SERVICE BULLETIN

PURPOSE : CHANGE	ISSUE NO. : MSB-13EXML11-005	DATE : 2013-11-18
SUBJECT : CHANGE OF THE IDENTIFICATION MARK OF THE PISTON RING NO.1		<DESTINATION/MODEL> (AS PER ATTACHED SHEET 1) <M/Y> 13-14
GROUP : ENGINE(Gr:11)

>>C<< PISTON RING NO. 2 / PISTON RING NO. 1 INSTALLATION

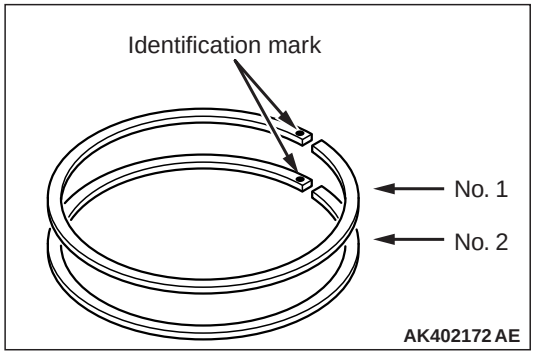
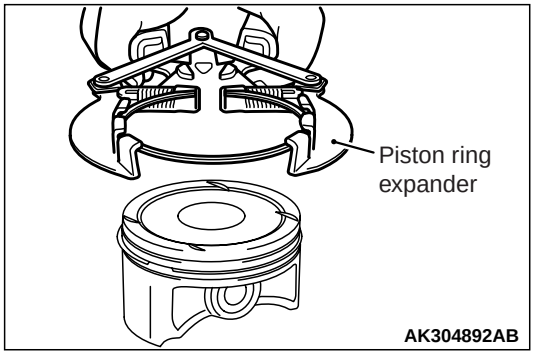
Use a piston ring expander to install the No. 1 and No. 2 piston rings. The ring identification mark should face upwards.

Identification mark
No. 1 ring: ~~N/T~~ <Old>
No. 2 ring: TT

T <New>

>>C<< PISTON RING NO. 2 / PISTON RING NO. 1 INSTALLATION

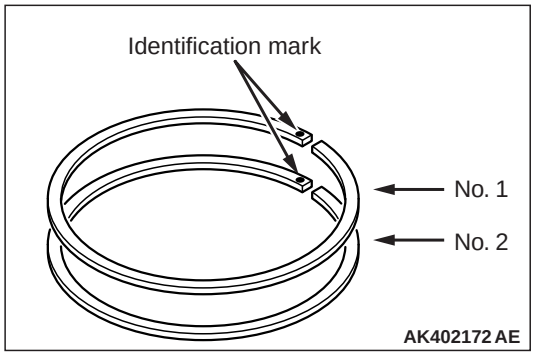
Use a piston ring expander to install the No. 1 and No. 2 piston rings. The ring identification mark should face upwards.

Identification mark
No. 1 ring: ~~N/T~~ <Old>
No. 2 ring: TT
T <New>
